Zoning Update Overview

“Mini Reform” Part One

Comments & Input on Proposed Amendment(s)

17-21 State Street (Brine/Fowles Storefront)
(window operation & historic character are both protected)

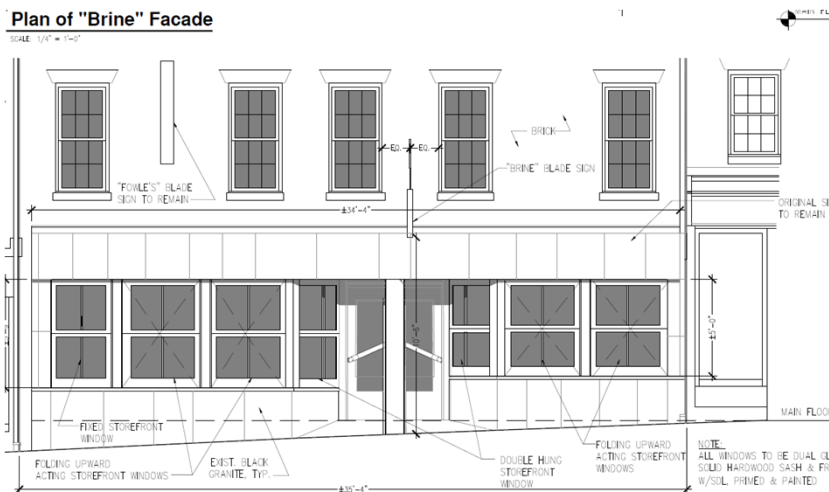
- Current language explicitly prohibits changes to “mode of operation”
- Proposed language allows this via Special Permit
- **Historic** windows must still be preserved/repaired if possible prior to their eligibility for replacement

27 Hancock Street

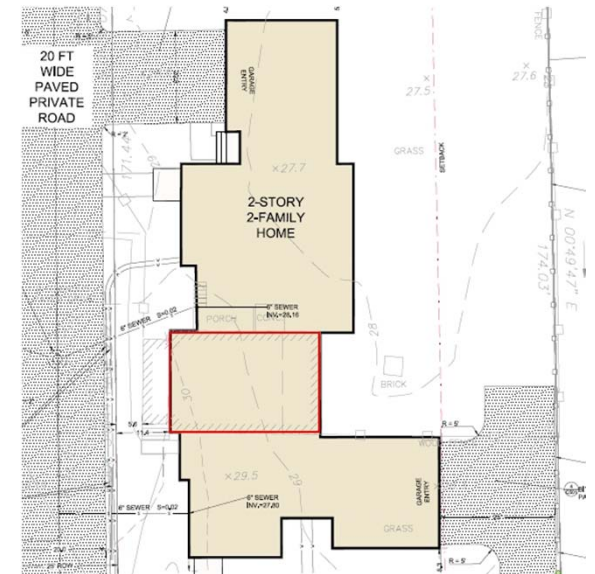
*(enveloping a historic structure = destruction of its **exterior** walls by conversion to interior = demolition)*

Diagram A

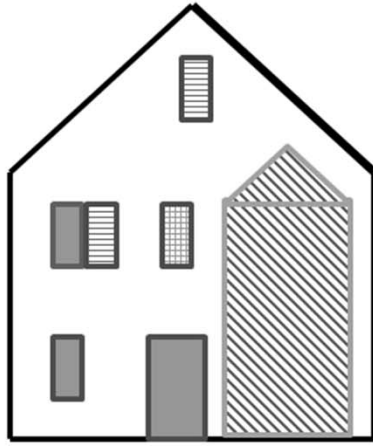
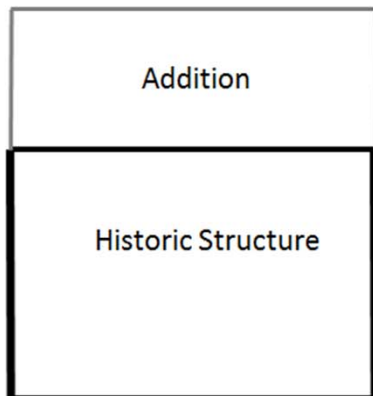
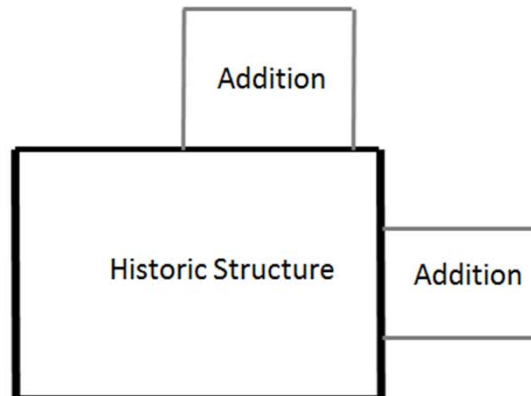
- External wall area (framing and sheathing) to remain exterior and be resided does not count as demolition
- Existing windows/doors to be replaced with windows/doors DO NOT count towards demolition
- New or enlarged openings in external walls count as demolition
- Existing opening to be infilled with wall area count as demolition as they are NOT being replaced in kind
- Wall area behind addition counts towards demolition
